Service Bulletin

Bulletin No.: PI0998C

Subject: Accessory Tri-Fold Tonneau Cover Prevents Endgate/Tailgate from Closing

Models: 2014 Chevrolet Silverado 1500
2015 Chevrolet Colorado, Silverado
2014 GMC Sierra 1500
2015 GMC Canyon, Sierra

3461386

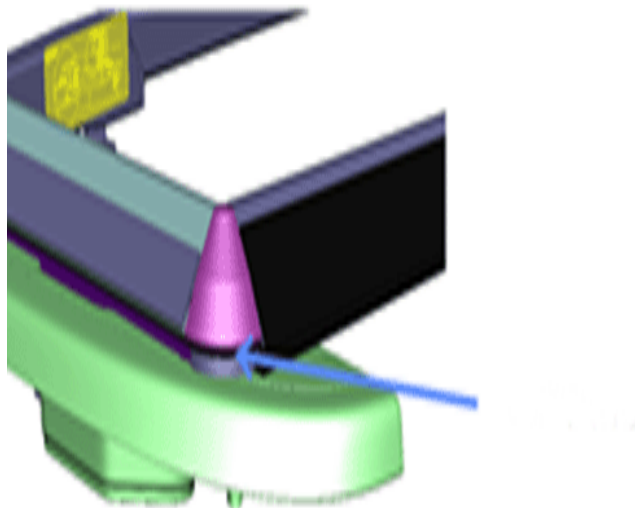
Some customers may comment that the tailgate will not close with the tri-fold tonneau cover in the closed position. This may be due to an early production condition caused by excessive twist in the rear rail of the tonneau cover, and the tailgate molding is not positioned flat on top of the tailgate.

2. Remove the adhesive liner from the pad and attach to the rear current corner pads on the right and left side as shown in the illustration above.

Note: If additional clearance is required, add a second layer of corner pads to each side.
